Access Compliance Report Public Rights-of-Way (Curb Ramps)

Main Street: MAIN_ST Cross Street: RESTON_WAY Location: S

ADA ID: RPRK211101130351 Ramp Type: Type 4 - Parallel Initial Pass/Fail: Fail Overall Compliance: No Severity Score: 32

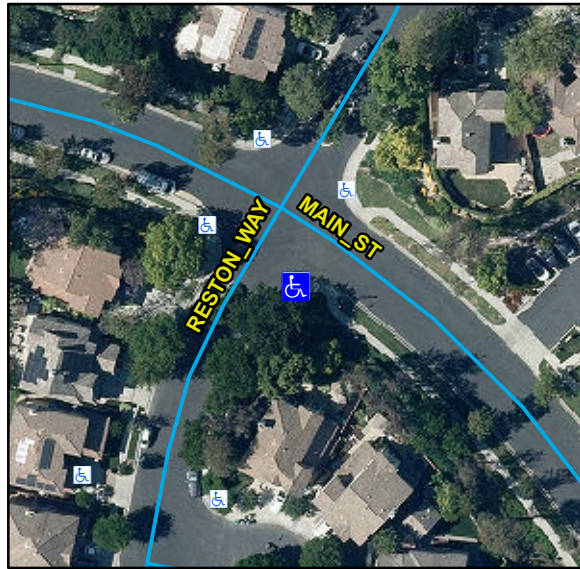
Possible Solutions:

Remove & Replace Curb Ramp With Two New Directional Ramps or Equivalent.

R204.3, R304.5.3, R304.3.2, STD 1115
